#### **Addendum 69 – Regulation No. 70**

#### **Revision 1 - Amendment 3**

Supplement 9 to the 01 series of amendments – Date of entry into force: 15 June 2015

#### **Uniform provisions concerning the approval of rear marking plates for heavy and long vehicles**

Figure 3a

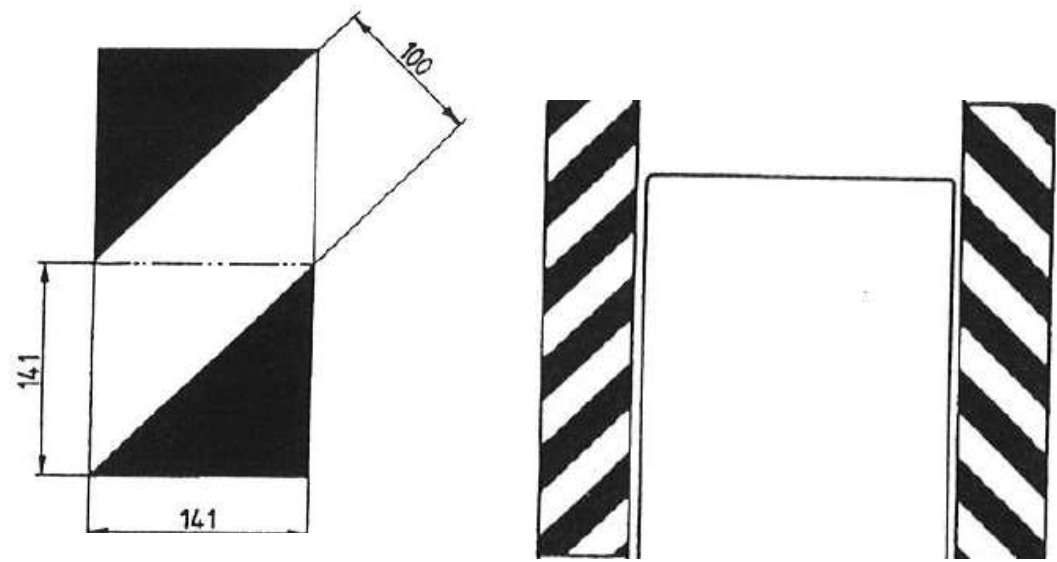
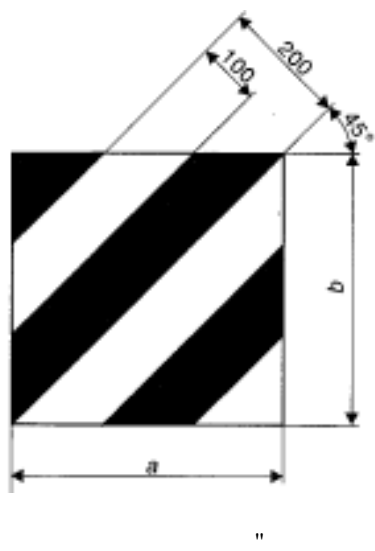
After Figure 2, insert a new title and new Figures 3a and 3b to read:

"Rear marking plates (Class 5)

Figure 3b  
Example for a plate design

"3.4. ...  
Class 5 retro-reflective materials shall consist of red and white diagonal stripes each 100 mm wide sloping outwards and downwards at 45°. The basic standard area is a square of 141 mm in length subdivided diagonally into a white half and red half, which represents one standard area.  
Prescribed shapes, patterns and dimensional features of Class 5 devices are illustrated in Figure 3 of Annex 12 to this Regulation."
